QUALITY CONTROL REPORT

Independent LiDAR Quality Control Report
Calvert County Area of Interest

CATS II TORFP # 060B1400054
Digital High Resolution Aerial Photography (Orthophotography)

Figure 2 GPS base station baseline check. Area not within the 25-mile range of a base station is highlighted in pink

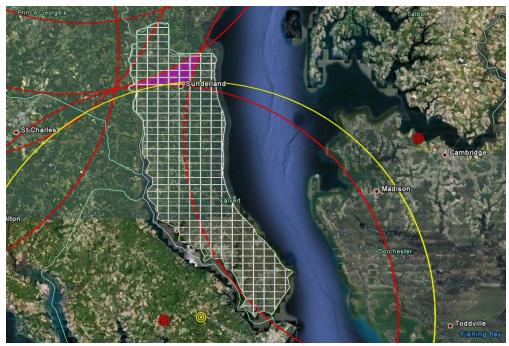
In the following graphic, there is a small area noted within the project (highlighted in pink) that is not covered by the minimum 25 mile range requirement.

URS does not consider this to be an issue as the aerial acquisition report and supporting data for Calvert County confirms that no issues were encountered during flight.

As a final check and assurance of this, URS inspected the delivered LiDAR LAS files in this area to ensure that a GPS time-stamp was present.

Figure 7 - TIN of tile containing building artifact in the ground points

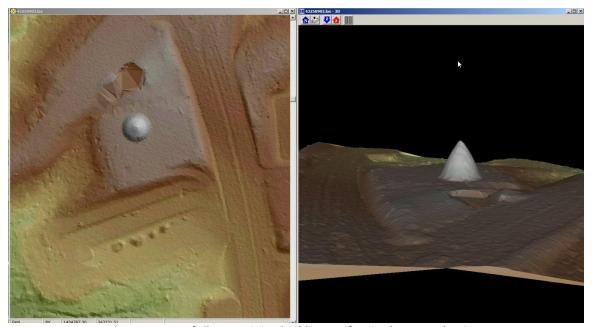
- Raw swath header records: the following issues were identified with the header records in the raw swaths delivered by Surdex –
 - A portion of the swaths delivered were produced using libLAS 1.2, which appeared to be the source of a header error where the headers displayed the incorrect number of points and the incorrect number of returns by point
 - The swaths with the above issue would not display correctly nor load into GeoCue
- 2 tiles in the AOI contained above-ground artifacts, which were found to be structures.

Figure 8 - The above image in the same location clearly showing a road salt storage facility

A non-systematic problem was found during the detailed check of the LAS classified point cloud files The check found a handful of LAS files that contained above-ground artifacts. Surdex redelivered the corrected tiles the same week when notified of the problem. URS subsequently checked the tiles to ensure that the corrections were made.

Figure 9 - Ground point misclassification. Ground points (pink) with yellow polygons should have been misclassified as water points (blue).

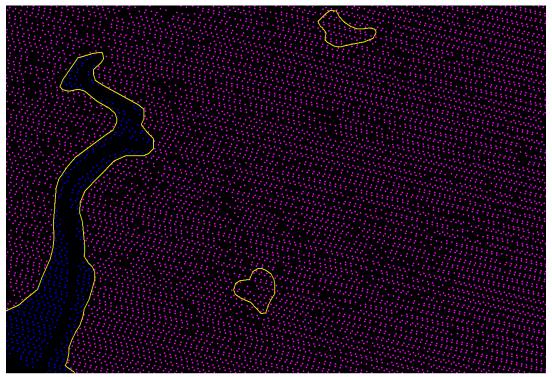
• 3 tiles in the AOI contained points misclassified as either ground or water. These were either an island within a hydropolygon misclassified as water or ground points within hydropolygons not classified as water. See Figure 9 for an example.

A non-systematic problem was found during the detailed check of the 3d hydro-lines. The check found a handful of tiles that had ground or water point misclassifications. These misclassifications were small in scope and only required minor edits. URS corrected the .las tiles using TerraScan.
